## SERVICE BULLETIN AMATEUR RADIO

| SUBJECT<br>TH-205 SIGNAL-TO-NOISE RATIO IMPROVEMENT   | DATE<br>10/28/88 |

FIGURE 3

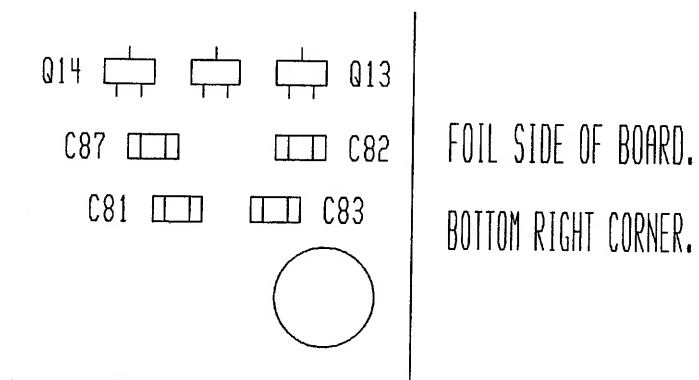
| <p>During strong signal reception, the noise level may appear to increase due to unstable action of the active filter in the PLL. To improve the signal-to-noise ratio, install a 390K ohm resistor on the emitter of Q12 (active filter) as described below.</p> <p>REQUIRED PART:</p> <p>390K OHM CHIP RESISTOR      PART # RK73FB2A394J</p> <ol style="list-style-type: none"><li>1. Disconnect the battery and antenna.</li><li>2. Remove the 7 screws from the back panel of the transceiver (Figure 1).</li><li>3. Lift the front panel from the transceiver and lay it to the right side.</li><li>4. Disconnect the 2 flex cables and remove the 3 screws from the IF unit (Figure 2).</li><li>5. Pull the top panel off and then remove the IF unit.</li><li>6. Remove the 8 screws from the RF unit and unplug connector CN2 (Figure 3). Remove the RF unit from the back cover.</li><li>7. Locate capacitor C82 on the foil side of the RF unit (Figure 4).</li><li>8. Solder the 390K ohm chip resistor directly on top of C82.</li><li>9. Assemble the transceiver by reversing steps 1 - 6.</li></ol> <p>This modification may be covered under warranty.<br/>Time required for this modification is 1.0 hrs or less. (C) 91188TKC</p> |                  |
